SERVICE BULLETIN

PRODUCT: Computer Monitor
BULLETIN: Monitor 95-001
MODEL: CVP4237P

SUBJECT: Part Number Correction

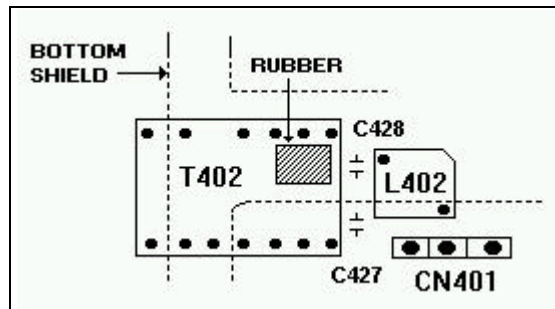
BACKGROUND: A whistling sound is created from harmonic noise generated between T402, L402, and the main PCB near the Flyback Transformer.

SOLUTION: Add a piece of rubber to insulate the main PCB solder side from the bottom metal shield. See Illustration below showing the section of the PCB where the rubber will be located.

Part No.	Description
BH61-30303A	RUBBER

Figure 1

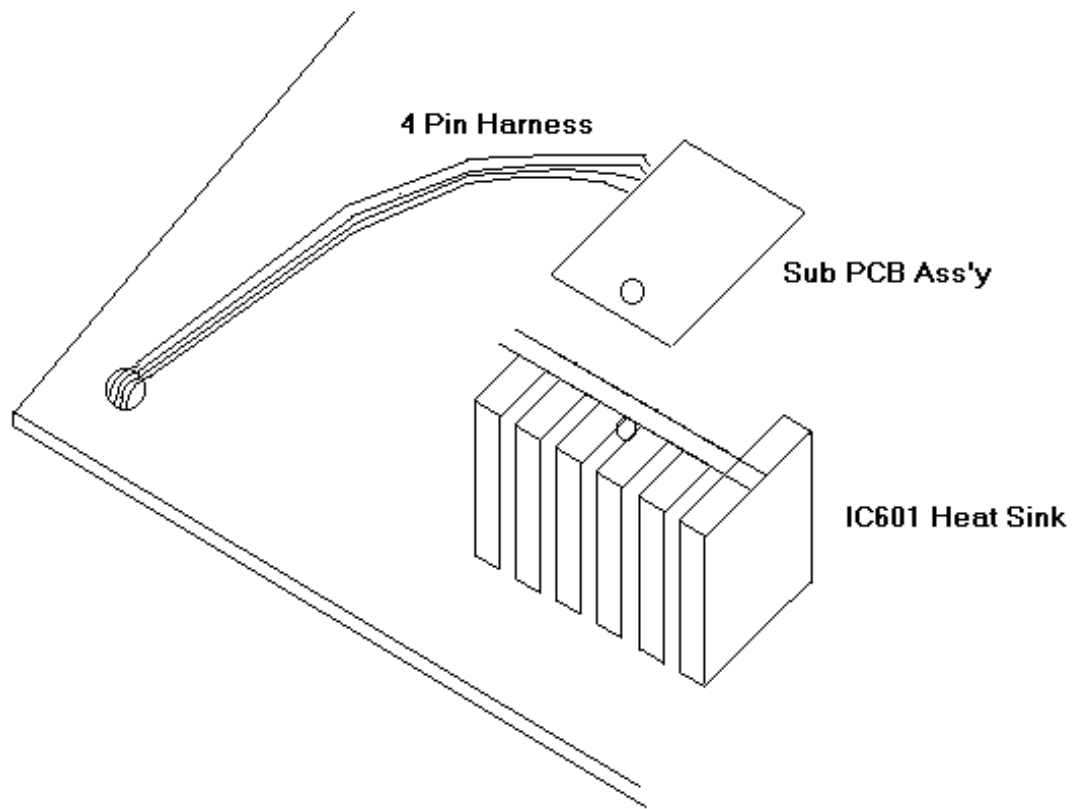
BACKGROUND: Q407 fails due to a transient pulse and current when mode switching from DOS to Windows. This occurs with a Matrox video card installed in the computer.

SOLUTION: Add a sub-PCB assembly as in figures 1 and 2 and a snubbing circuit for the horizontal output as in figure 3.

ORIGINAL			NEW	
Location No.	Part No.	Description	Part No.	Description
NA	NA	NA	BH92-50106J	SUB-PCB ASSEMBLY
NA	NA	NA	BH39-40355S	4 PIN CBF-HARNESS
NA	NA	NA	6003-000129	TAPTITE SCREW
NA	NA	NA	0401-000005	1N4148 DIODE
NA	NA	NA	0402-000012	UF4007 DIODE
NA	NA	NA	2003-000009	220 OMHS, 1 WATT
